Access Compliance Report Public Rights-of-Way (Pedestrian Signals)

Main Street: **CARBON_CANYON_RD** Cross Street: **SANTA_FE_AVE** Location: **SE**

ADA ID: **SGAT210920125533** Signal Type: **One Push Button-APS** Overall Compliance: **No** Severity Scores: **BTN 1: 0 BTN 2: N/A No BTN: N/A**

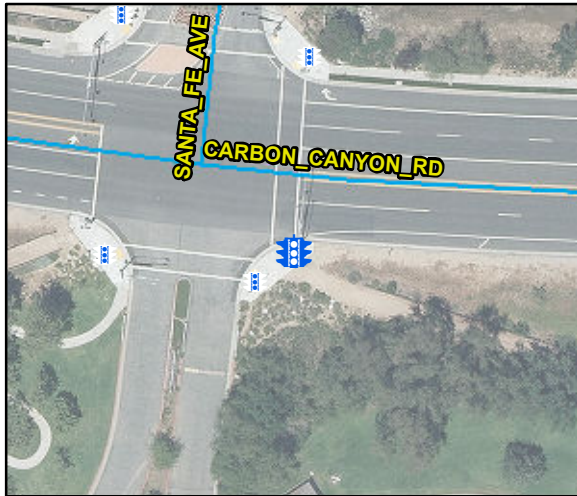
Yes	B 1 Diameter (in)	2.25	N/A	B 2 Diameter (in)	N/A
N/A	B 1 Crossing Direction	N	N/A	B 2 Crossing Direction	N/A
Yes	B 1 DistanceTo XWalk (in)	0	N/A	B 2 DistanceTo XWalk (in)	N/A
No	B 1 DistanceTo Curb (in)	98	N/A	B 2 DistanceTo Curb (in)	N/A
	Parcel Identification Number	322-031-23			
	Google Street View Link				
	http://www.google.com/maps/@?api=1&map_action=pano&viewpoint=33.92227259,-117.83682195

Possible Solutions: Replace Signal Push Button With APS Button. Remove & Relocate Sign.
